REVIEW

I BLASTING AND ATTENUATION STUDIES BY PROF. AIMONE-MARTIN

II PROPOSED ORDINANCE 15.33: BLASTING REGULATIONS

Prepared by C H Dowding
20 August 2005

one.jpg

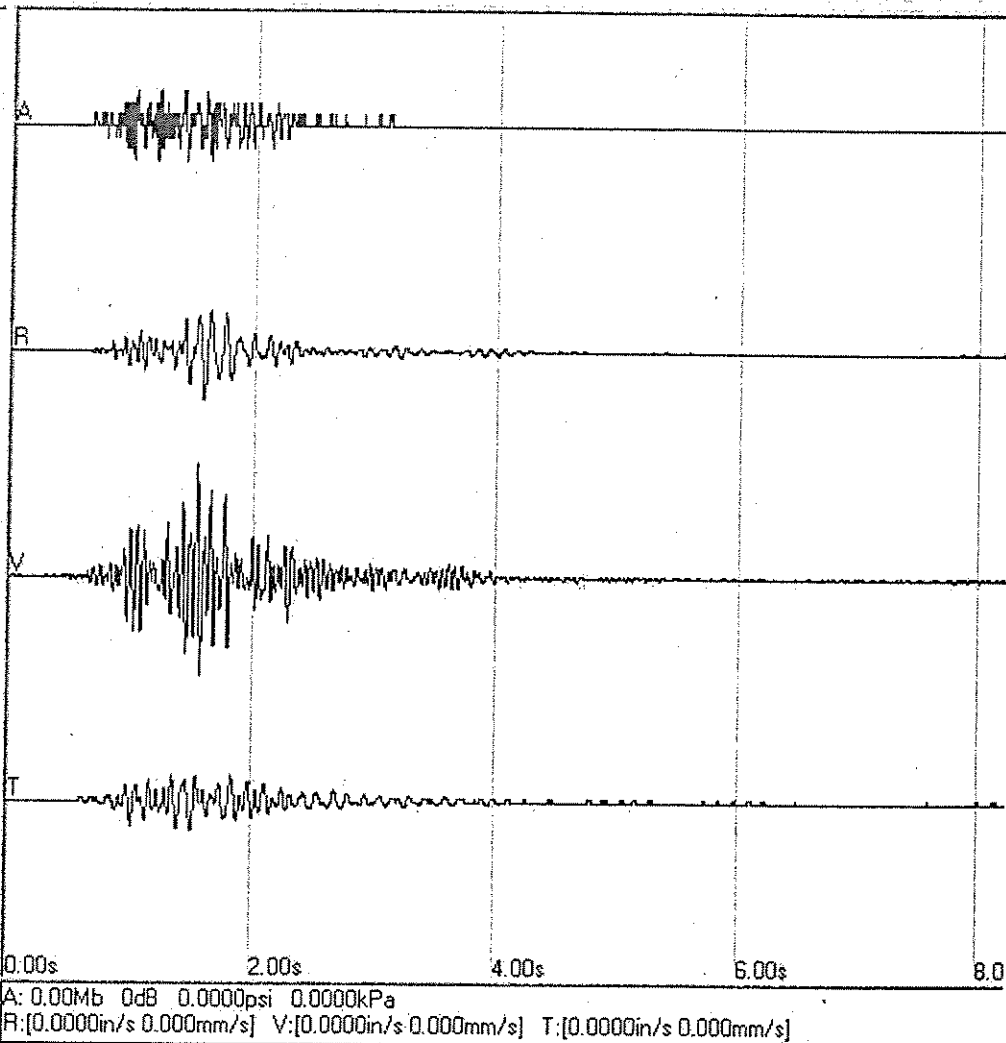
- 2) Variation in calibration signals of the vibration monitors is explained in the appendix. Specifically, the appendix explains the manner in which the calibration signals are employed to increase the accuracy of the reported response. These calibration signals are part of the in-depth provisions for validating measurements of blast vibration monitors that have grown over the more than 5 decades of the development of these instruments.

1. calibration of seismographs (see file *calibration date.doc*)
2. problems with S2 sensors/seismograph 2279 in the structure at Big Horn (see files *one.jpg*, *Big Horn.xls*)
The *one.jpg* file is a screen capture of the seismograph report showing the cals for the shot on
3/16/05 at 13:52,

Most definitely the unit 2279 was inadvertently set on 1X gain (lowest velocity resolution is 0.01 ips) while the gain for the sensors were manufactured at 2X (lowest detected is 0.005 ips). Generally when this type of gain "mis-match" occurs with a traditional tri-axial geophone, the readings will shown two times larger than normal and the R, V, and T components will cal at ~ 1.0 ips rather than ~0.5 ips (or a 100% greater cal).

In this case, when using a tri-axial geophone, we simply divide the peak value reported and values for all time histories by 2 to obtain the adjusted (corrected) amplitudes (the same holds true for displacements).

However, for some reason the single-axis transducers show a cal at 50% greater rather than a 100% greater with the same gain mis-match. In other words, instead of a 0.5 ips cal, they show at 0.75 ips cal. Now if you look at the variation in the data (I took a random check though a few shots) I found the range to be 0.74 to 0.84 ips while it theory it should vary about 0.75 ips .

What I always do in these cases is to adjust the peaks reported and the time histories by a factor equal to the following (using the data for 3/16)

NULL COMPARISON.xls

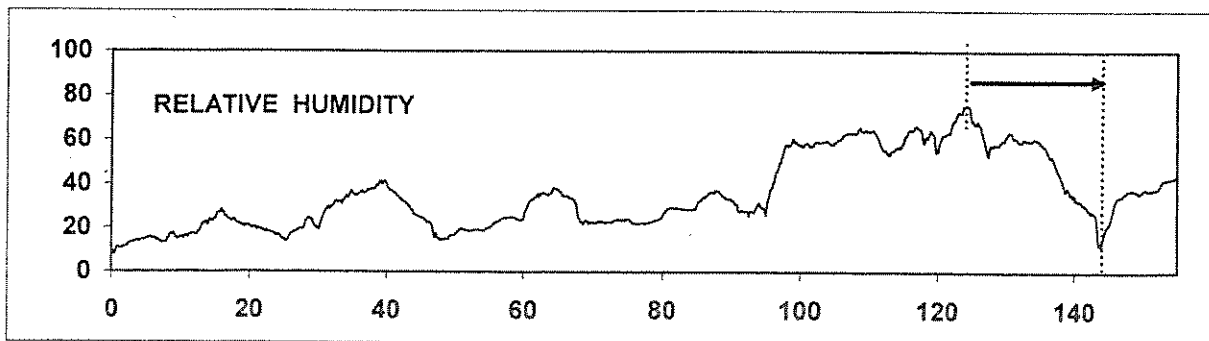
- 1) Long term and dynamic responses of the null crack sensors are supplied in the appendix. The null sensors are employed to verify that measured crack responses are caused by crack widening and narrowing and not that of the sensor itself. This information confirms the proper functioning of the instruments measuring crack responses

why using the null is insignificant when crack response alone is very large:

Take the two times at 122 hr (blue line) and 141 hr (red line) where the crack is wide and the lowest. Computing the overall difference that influences crack potential:

at 122 hr	at 141 hr	overall change due to humidity (see plot right)
crack	+1615.7	-2799.4	4415 micro-in
null	- 347	- 323	24
difference	+ 1268.4	-3122	4390.4

the error in estimating the largest variation in crack movement by considering only the crack alone and ignoring the null gage data over this time period is

$4415 - 4390.4 = +35$ micro-inch error (overestimating +opening) or $+35/4380 = +0.8\%$ error
 or $-35/4415 = -0.8\%$ error (which ever way you want to look at the error)

Figure 2 Structure outline showing locations of instrumentation (a) and photographs detailing Instrumentation (b)

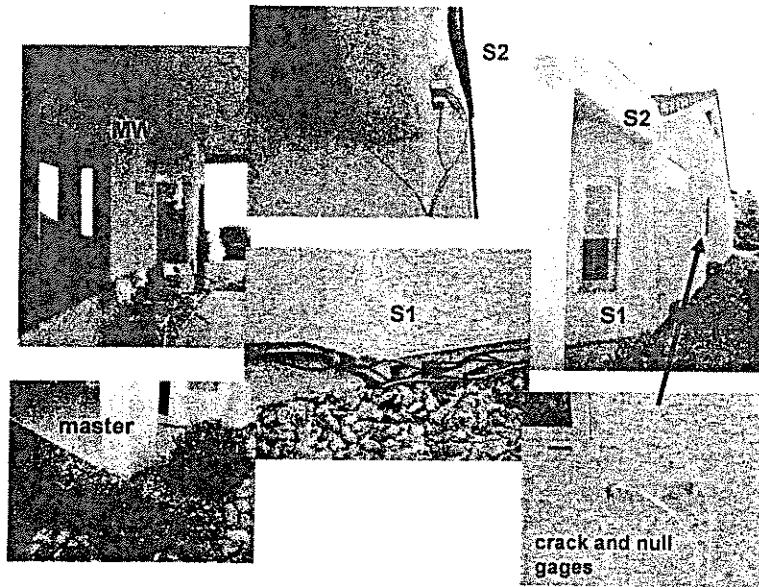
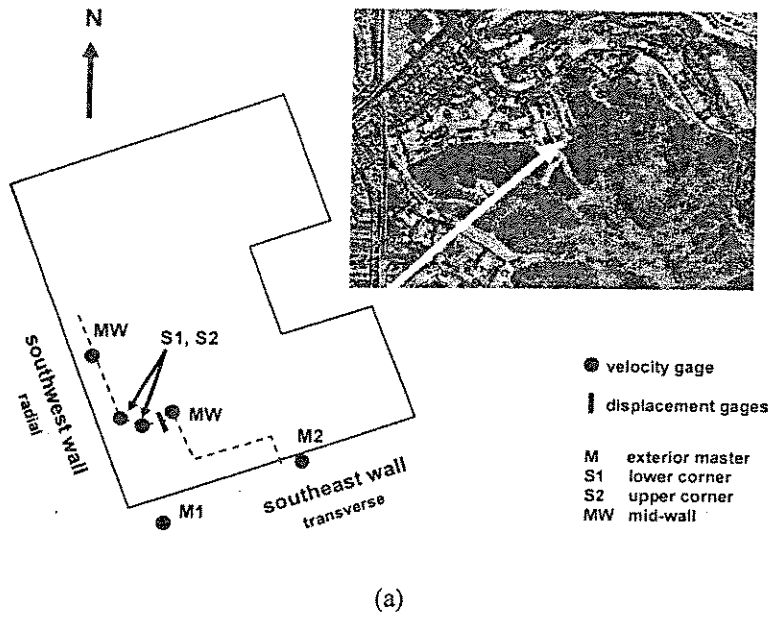
- 4) Photographs and/or drawings of the instrumented crack locations relative to the instrumented corners and mid walls were provided. These are the missing Figures 2 and 3 of the report, which should be added to the version on Henderson’s web site.
